**AMENDMENTS TO THE DRAWINGS**

**REMARKS**

The Office Action mailed May 30, 2008 (hereinafter, "Office Action") has been reviewed and the Examiner's comments considered. Claims 30-39 are pending in this application. Claims 34-36 are withdrawn from further consideration as being drawn to a non-elected Species. No amendments to the claims are made herein. The specification and drawings are amended herein. Applicant submits that no new matter has been introduced.

**FIG. 7D**

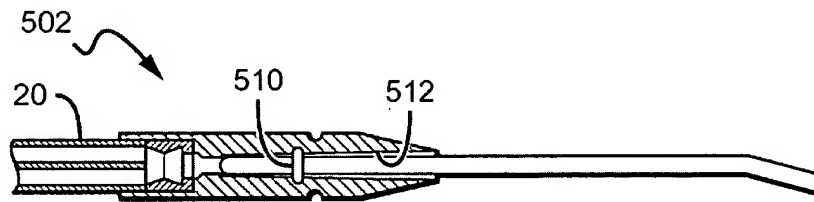
Second, the Examiner is incorrect in asserting that the claimed language does not match with the drawings. As the drawing below clearly shows, there is no inconsistency between the claim and specification disclosure pursuant to MPEP § 2173.03. In particular, the Examiner is conflating distal and proximal as shown below, and has mistaken tunneler 50 for catheter 20. Further, although believed by Applicant to be unnecessary, in the interest of compact prosecution, Applicant has included herein new FIG. 7D to show the features clearly described (*see* paragraph [0047], a section of which is reproduced below) in the instant specification with respect to elected species 7A-7C.

After the catheter is placed and the tunneler is positioned in the subcutaneous tunnel, the proximal end of the connector housing 502 is slid over the tip of the tunneler 50. A compression ring, such as O-ring 510, grips the tunneler tip, allowing the catheter to be withdrawn through the subcutaneous tunnel by pulling the connector 502 through to an exit site. As described above, a wall 512 defining a portion of the passageway proximal the O-ring may be tapered.

FIG. 7D

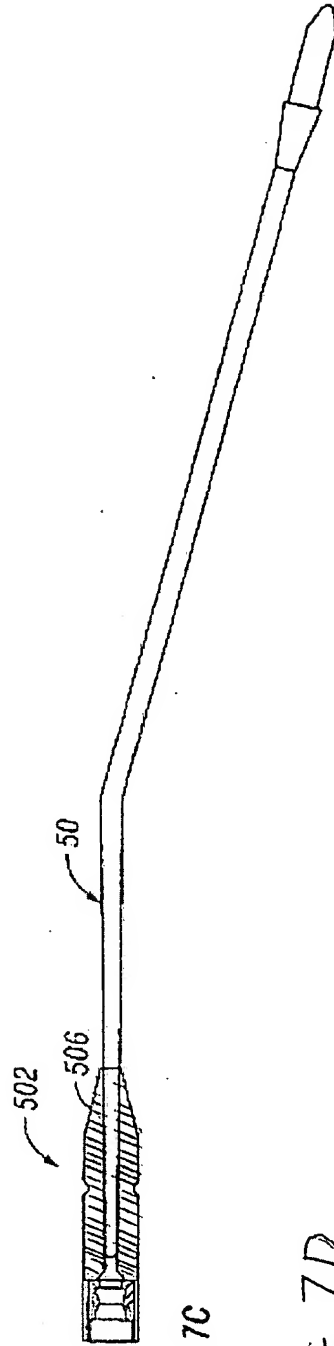
The attached sheet of drawings includes changes to FIGS. 7A-7C and the addition of new FIG. 7D.

Please amend FIGS. 7A-7C to include cross-hatching to more clearly show the components as in FIGS. 1-3.

Please add FIG. 7D to show an O-ring and a wall defining the proximal portion of the passageway proximal of the O-ring being tapered. Support for FIG. 7D can be found in the originally filed application at, for example, paragraphs [0042] and [0047].
